Universal Jointing Consortium

Bulletin Number: UJCB091 Issue 1

UJ/UC C-SAMS CONTROLLER 240V PLUGS AND SOCKETS

Figure 1 – 240v input sockets identified in red.

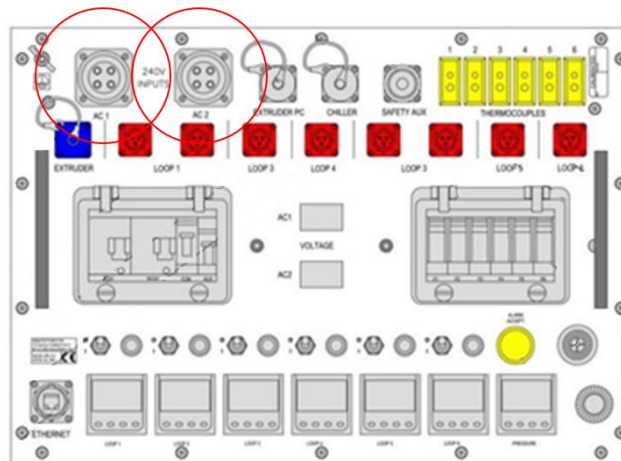
During the life of any product, product changes are sometime imposed due to the discontinuation of parts. This bulletin provides insight and recommendations to the change of the 240VAC input connections (items with red circles in Figure 1) and their corresponding connector on the electrical supply cable.

Due to differences in the connector, users are advised that the electrical supply cables for C-SAMs controllers prior to serial number 463 may not be interchangeable with subsequent units.

For information, controllers prior to serial number 463 were supplied with electrical supply leads to drawing number P06SS0807 and afterwards P10SS0441. However, this is only a guide as the controller may have been reworked and the connectors changed. The following is recommended:

- Regardless of the unit's serial number, physically check that the leads fit the controller before operational mobilization and ensure that these leads are retained with the unit.
- Take additional care of the cables and connectors. If either the cable or face panel connectors are damaged it may not be possible to obtain a replacement connector. In this case it will be necessary for the controller and cables be returned to base to be updated with the newer items.
